# DM/22/3214 No. 71 and Land South of Crawley Down Road

**Felbridge Parish Council strongly objects to this application**. Whilst it is accepted that development of this site has been agreed in principle by the adoption of DPD Policy SA19 following the examination in public, Felbridge Parish Council does not believe that the development proposal as submitted meets the criteria necessary for the application to be considered viable. It is unclear why the applicant is looking to bring this allocation forward in two phases. This does nothing to aid integration across the site and creates a greater risk of creating two separate developments. This is likely to have a further detrimental effect on the village and the adjacent neighbours. If the applicant is not minded to make a commitment on the site in one application we suggest that a design code that will apply to the full allocation is included as a condition, or ideally requested from the developer for consideration in advance of this application to secure a consistent approach to design across the site.

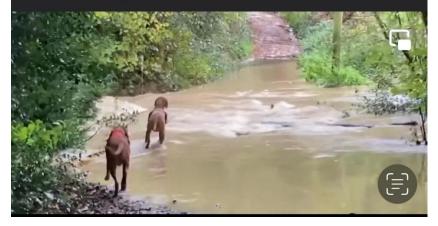
Felbridge Parish Council challenges the suggestion that there is virtually no flood risk zone within the site. Residents who walk these fields, and the adjoining bridleway, know there is regular flooding in this area extending to both sides of the Gullege Bridleway as shown in the photographs below taken over the past three years. The first image is the most recent and was posted as a warning to walkers on the Felbridge Facebook group on 6<sup>th</sup> November 2022.

Be very careful if you're walking from the playfields in Felbridge down the lane towards Gulliage house as this flow of water is deeper than it looks. Shortly after this my dog was washed into the pond. He's fine but would be dangerous for small children and dogs
